CHANGE ORDER FORM
DEP Contract No. SP644
Page 1 of 2

Change Order No.: SP644-014

**RE: Additional Panel Drains Change Order Revision 1
FDEP Contract Number SP644**

GYPSUM STACK SYSTEM CLOSURE
 SLOPE CLOSURE PHASE I
 PINEY POINT FACILITY
 MANATEE COUNTY, FLORIDA

DRAWING NO.
L-1

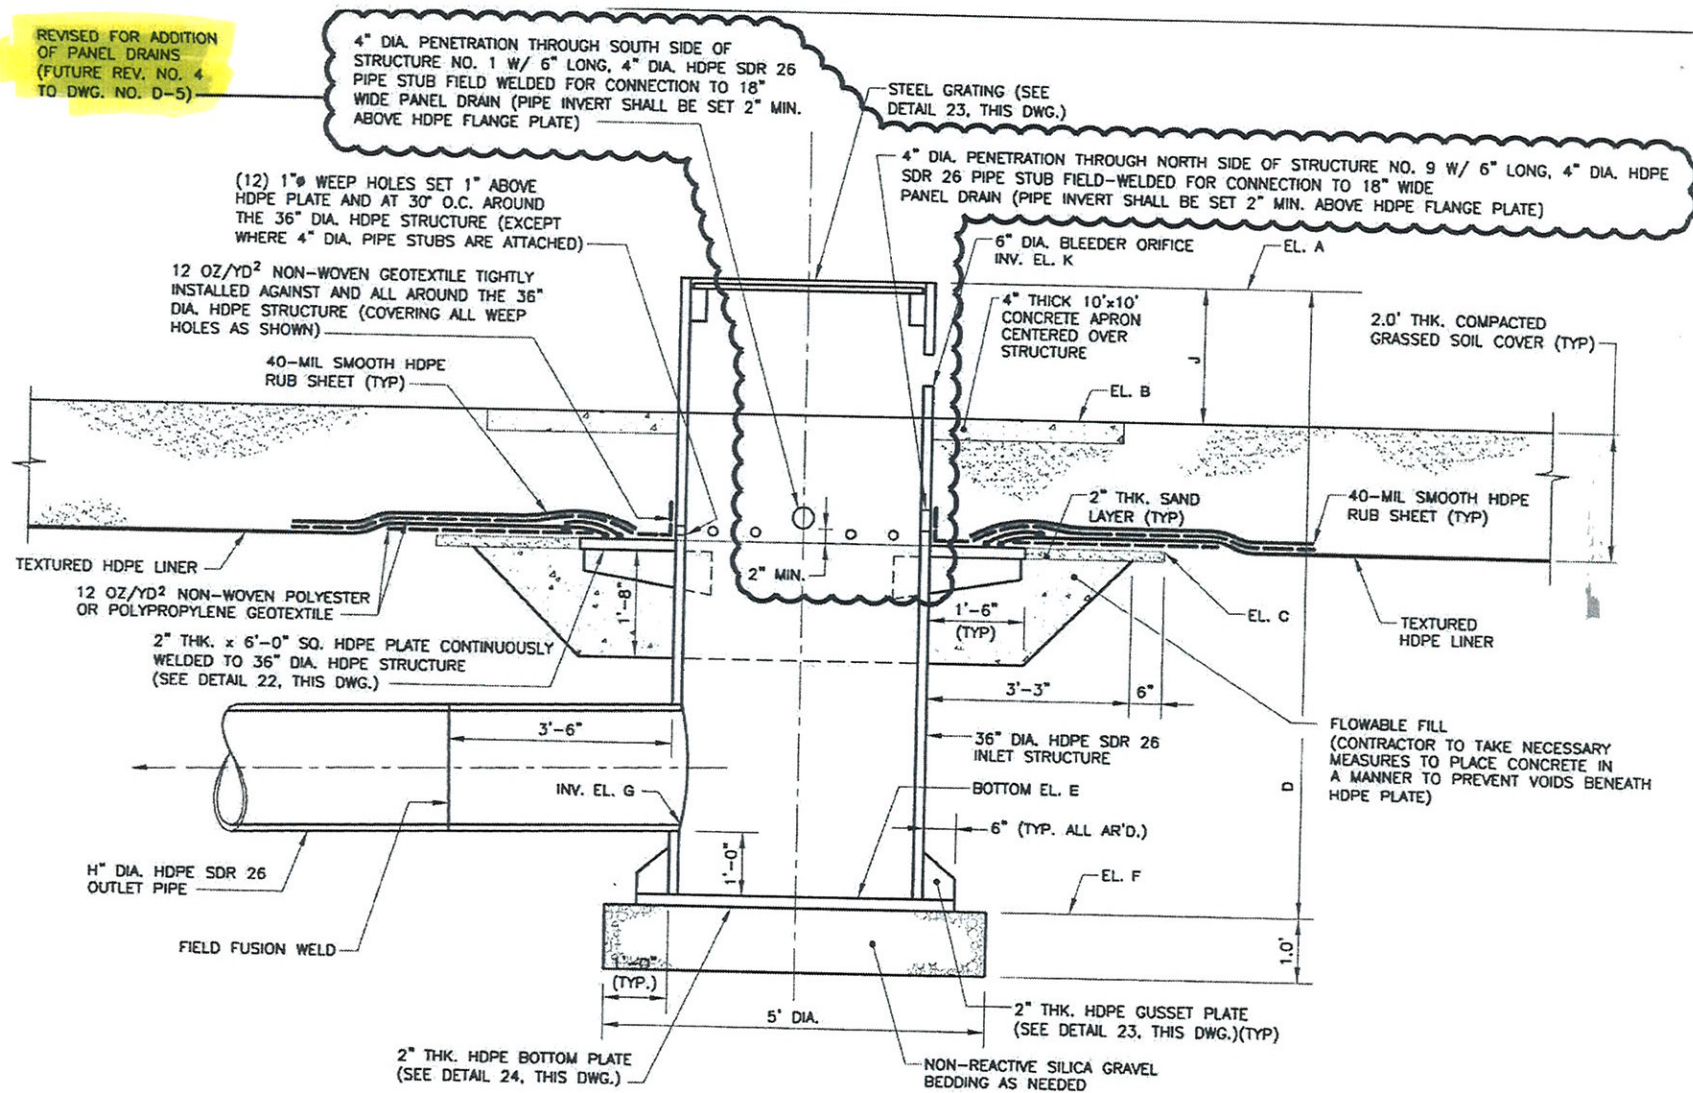
CDM Constructors Inc. hereby submits the following change order amount to the contract associated with the extending the existing OGS Slope Panel Drains and adding panel drains to specific Phase I and Phase II Stormwater Ditches as shown on the attached drawings. The changes are due to drainage problems within the OGS Slope Pond addition panel drains requested by the Engineer. The total amount of the proposed change order is an increase of \$37,938 to the contract amount. The attached spreadsheets provide a breakdown of the costs associated with this change. The proposed changes are generally as described as follows:

A total of 200 feet of panel drain will be connected to Inlet Structure No. 9 and 400 feet of panel drain will be connected to Inlet Structure No. 1. The work will be done in coordination with the placement of cover soil in each area.

REVISED FOR ADDITION
OF PANEL DRAINS
(FUTURE REV. NO. 4
TO DWG. NO. D-5)

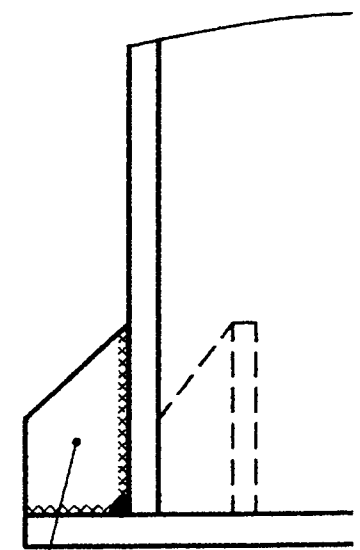
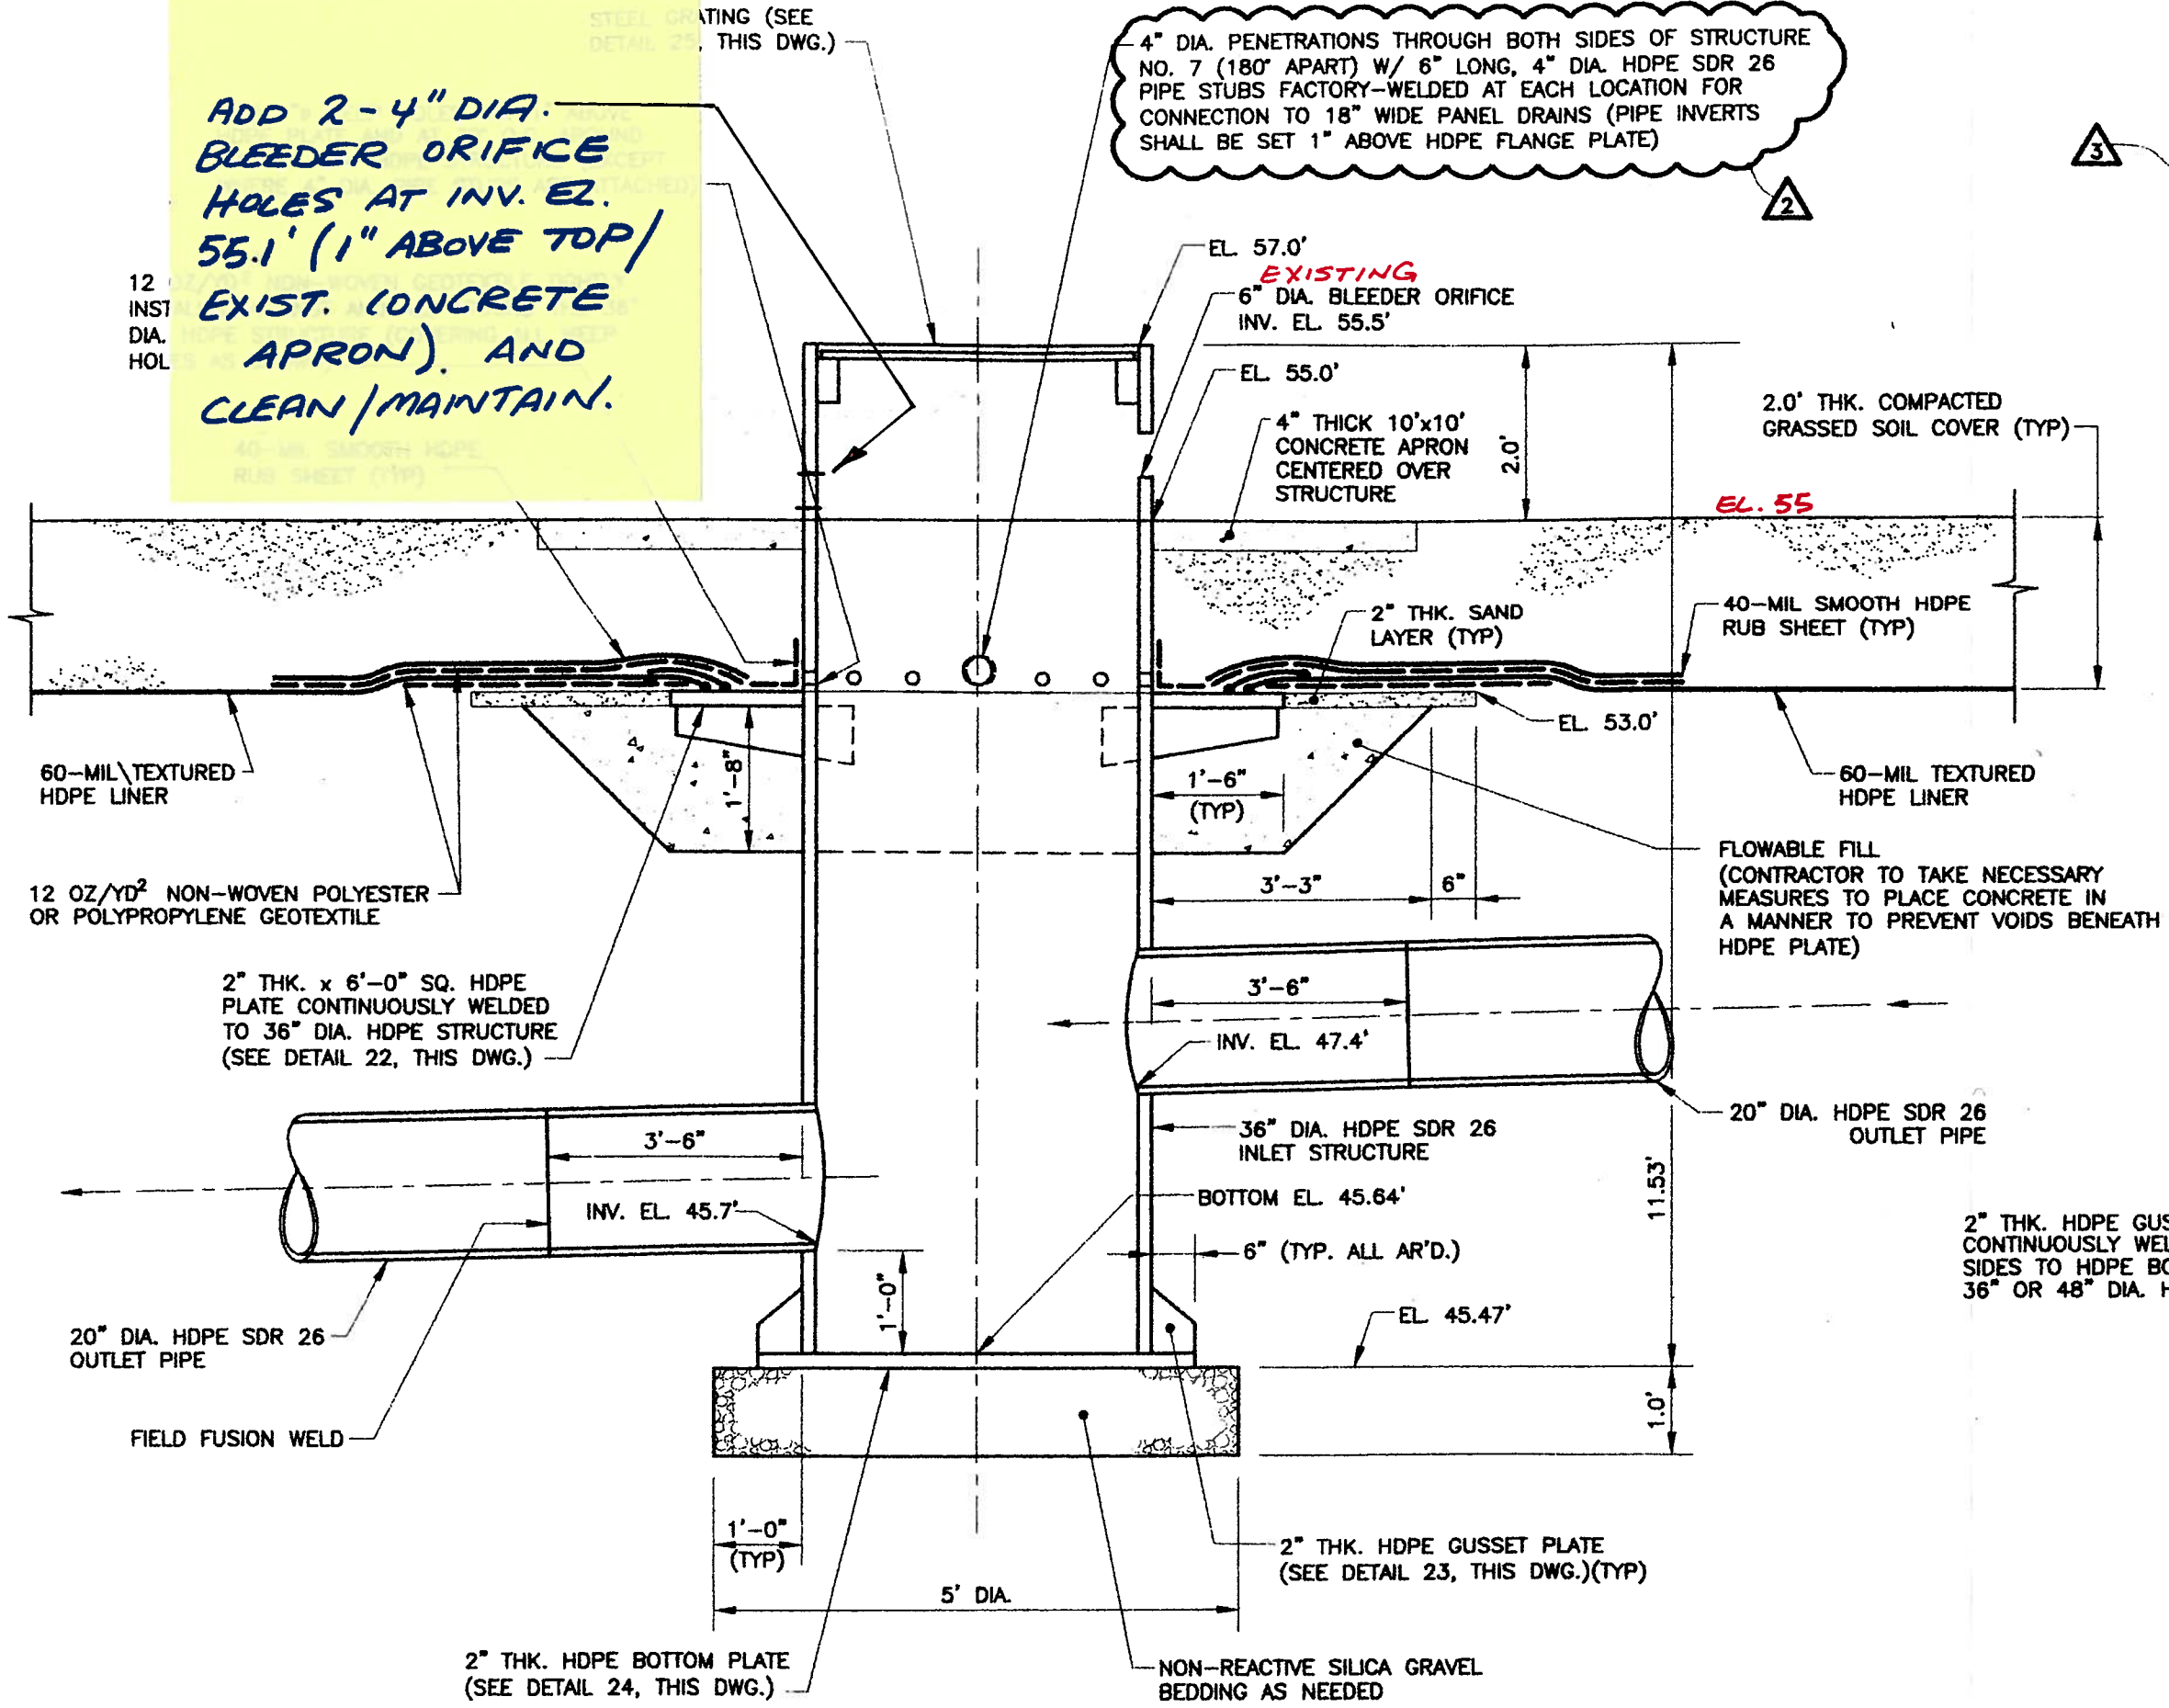
John,
The change order proposal includes minor modifications to Inlet Structure #7.
Dean

Please confirm whether the modification to inlet structure No. 7 in the OGS Slope Pond, as discussed by Rob below, is included in the proposed scope and cost. If so, we will proceed with a change order based on the recommendation outlined herein.

ADD 2-4" DIA. BLEEDER ORIFICE HOLES AT INV. EL. 55.1' (1" ABOVE TOP/ EXIST. CONCRETE APRON). AND CLEAN/MAINTAIN.
